Martin Place Station Precinct North Stage 2 - Modification 2

Design changes – Level 10 eastern facade setback and Level 3-4 floor levels
State Significant Development Modification Assessment (SSD 9270 MOD 2)

December 2020

Figure 2 | Setback increase proposed for the eastern tower façade on Level 10

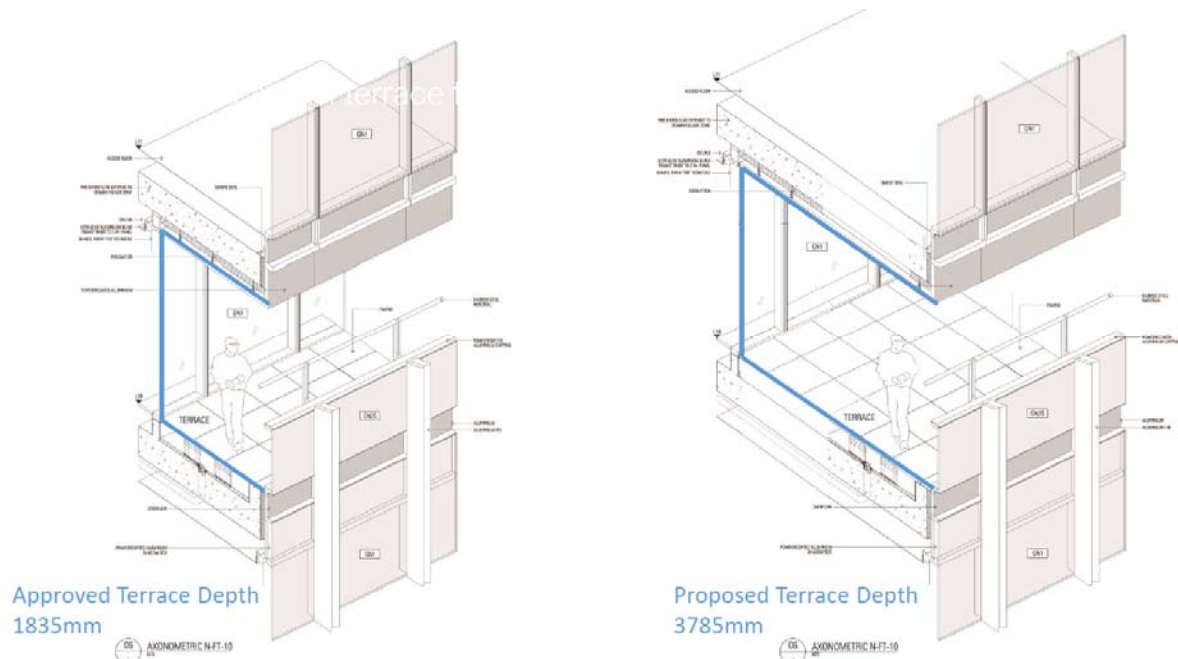
The modification application seeks approval for increasing the eastern facade setback / terrace on Level 10 from 1.84 metres to 3.79 metres (**Figure 2**) and increase the height of the external spandrel panels on Levels 3 and 4. The recessed aluminium facade panel is proposed to be adjusted by 100mm to align with the raised floor level (**Figure 3**).

The Department supports the proposed changes to Level 10 which reinforce the podium's relationship with the heritage item, 50 Martin Place and the consistent podium height along Elizabeth Street (**Figure 4**).

- a) the increased Level 10 setback is consistent with the original design intent, and materials and detailing and will have a positive impact to the approved project
- b) the increased floor heights will have no discernible impact to the approved project.

Figure 3 | Proposed increase in spandrel height on Levels 3 and 4

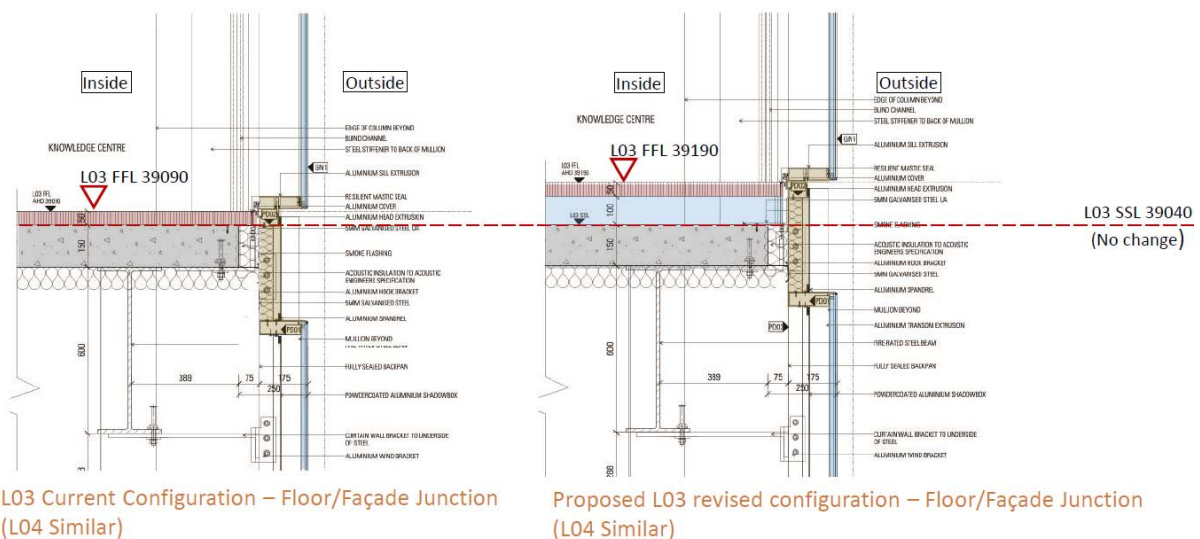
The Department also supports the proposed changes to Level 3 and 4 floor's spandrel heights as they have no noticeable impact on the appearance of the development, given the minor nature of the change in height (100mm) (**Figure 5**).
